Field Safety Notice

SBN-CPS-2017-003

cobas[®] 8100 BRF and URF with Software Version 02-xx: Buffering May Cause Specimen Spillage

(Fig 1: English version of screen)

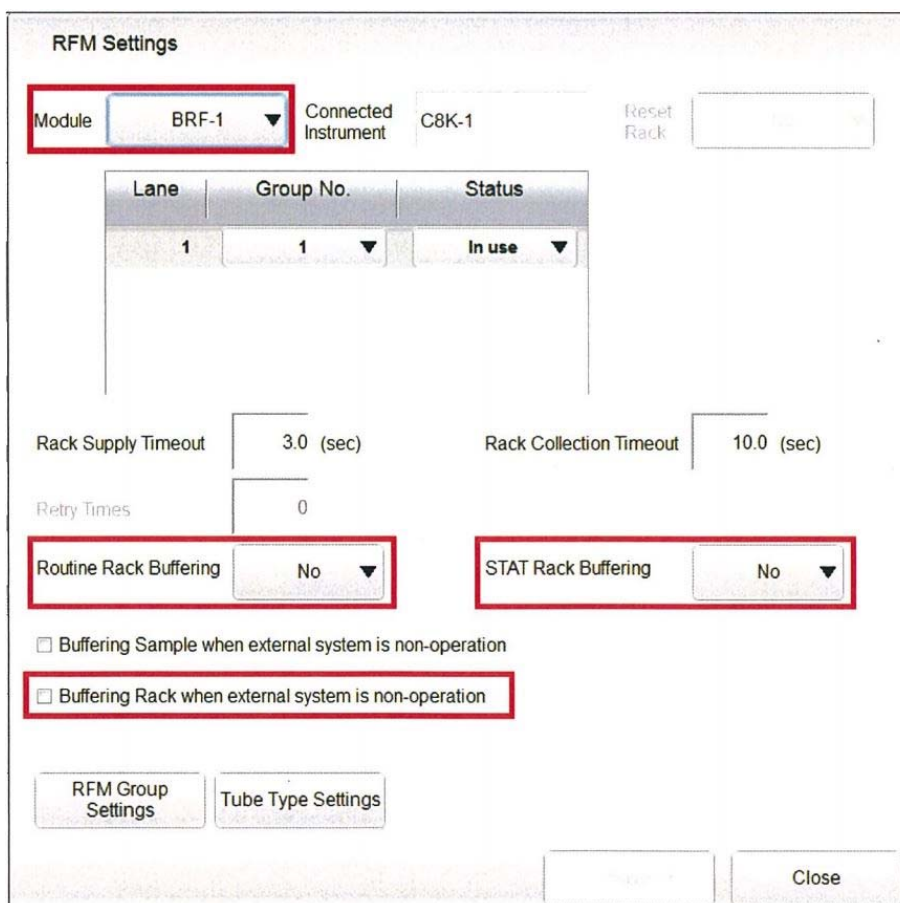
The rack buffering for all BRF and URF modules is required to be disabled in the configuration of the Control Unit, until software version 03-01 is installed. Once version 03-01 is installed the rack buffering for all BRF and URF modules can be re-activated.

Procedure to disable rack buffering:

1. Open the RFM Setting Screen.
2. Choose BRF and URF from the pull-down menu for "Module".
3. Set "Routine Rack Buffering" to "No".
4. Set "STAT Rack Buffering" to "No".
5. Uncheck "Buffering Rack when external system is in non-operation".
6. Press "Save" button.
7. Repeat steps 2 to 6 for all connected BRF and URF modules.
8. Reboot the system.
